From: Trickett, Sam
Sent: Tuesday, 24 November 2020 3:08 PM
To: Chung, Jenny
Subject: FW: [EXT]:RE: Lendlease Project - Barangaroo South - Construction Traffic Management Plan (CPTMP)
Attachments: RE: [EXT]:FW: Lendlease Project - Barangaroo South - Construction Traffic Management Plan (CPTMP)

Thank you for providing TfNSW with the Construction Traffic Management Plan (CTMP) Barangaroo South.

Lendlease are proposing to relocate an existing entry gate for their Barangaroo South Construction compound on Hickson Rd 10m south of its existing location, refer markup attached.
Cardno are currently preparing a CTMP to reflect this change.

Client Lendlease
Project HICKSON ROAD TCP
Title TCP 07 - General Site Access Gate H3 and Exit Gate H1
19/10/2020

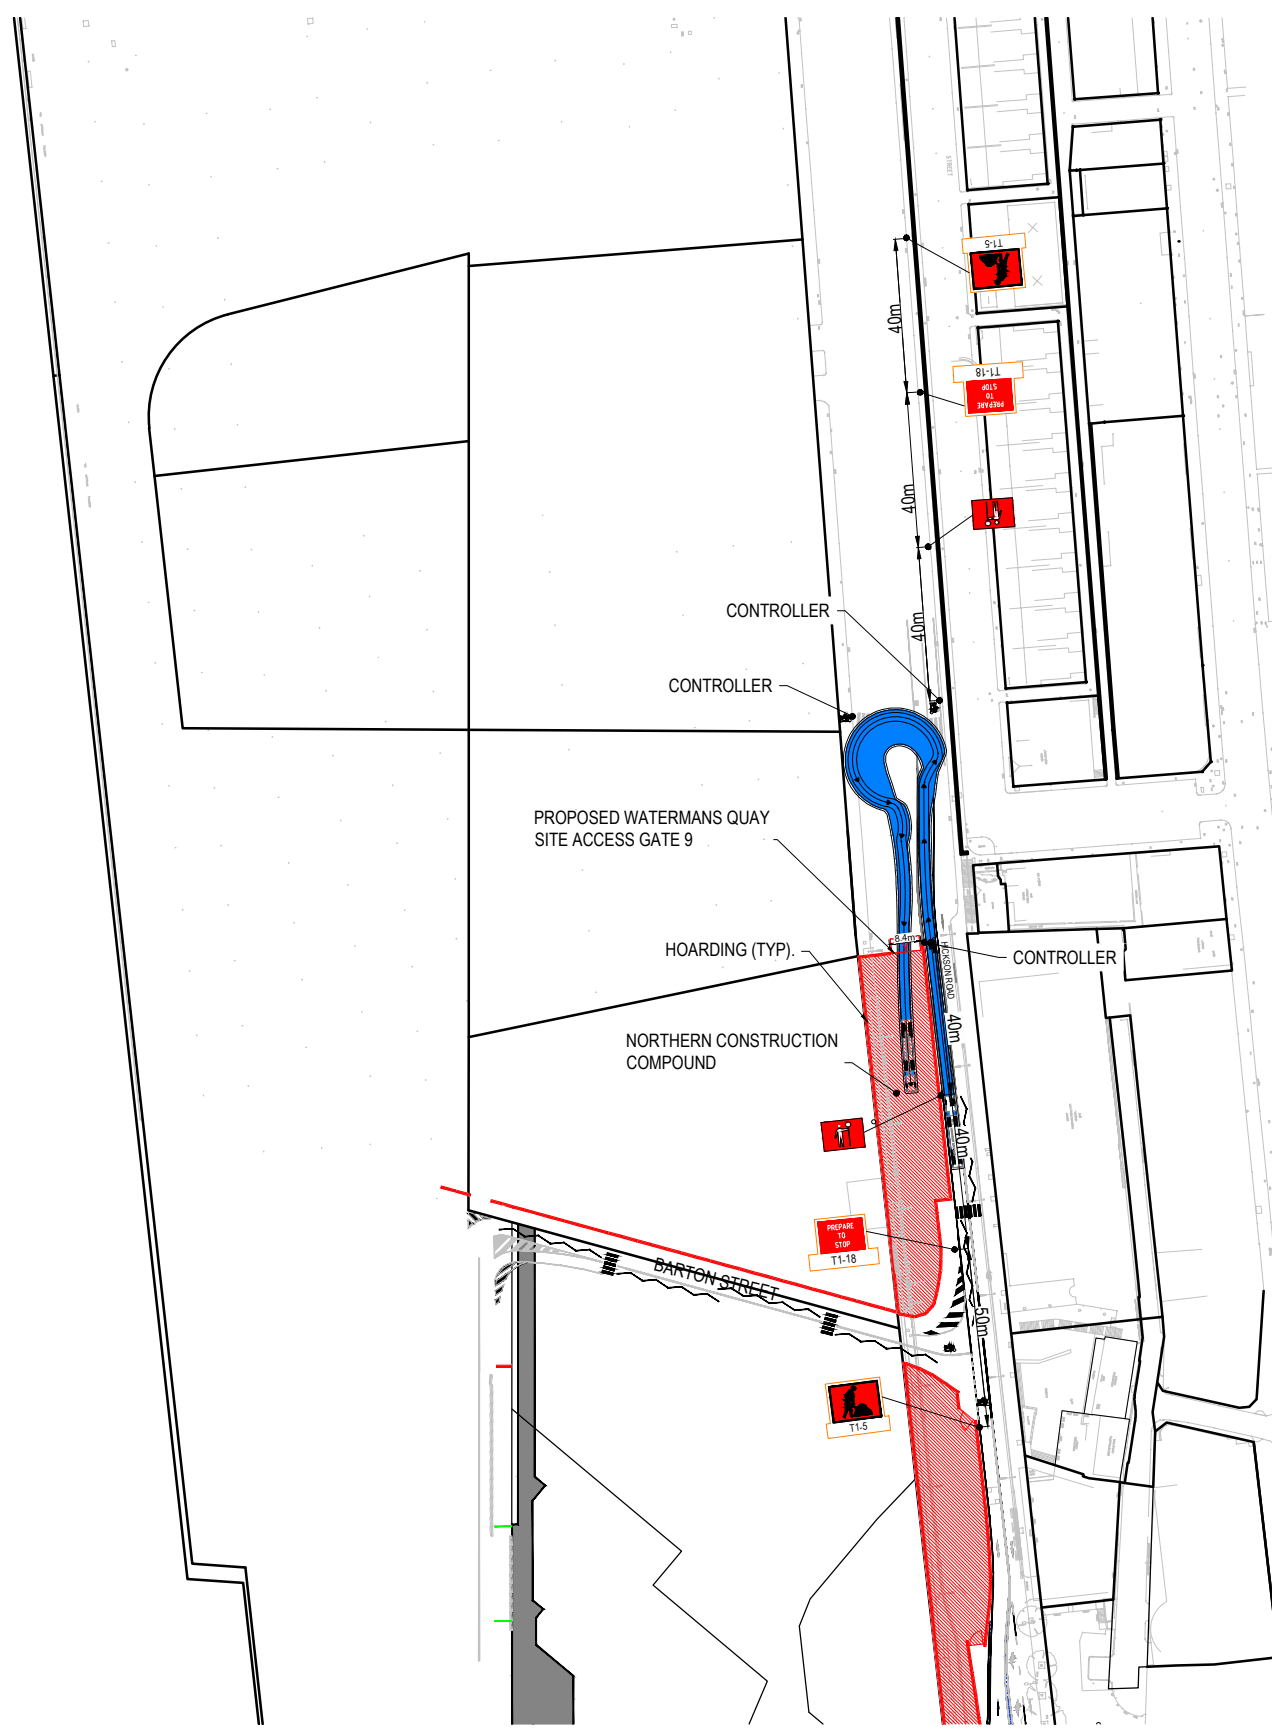
I have reviewed the change and the only comment I would like clarified is when a vehicle is to enter the gate will they need to wait till for the gate to be opened? If so it needs to be ensured that it does not queue in the lane.

Lendlease have confirmed that Gate H3 will remain open and traffic control present to manage vehicles entering site. (refer attached email)
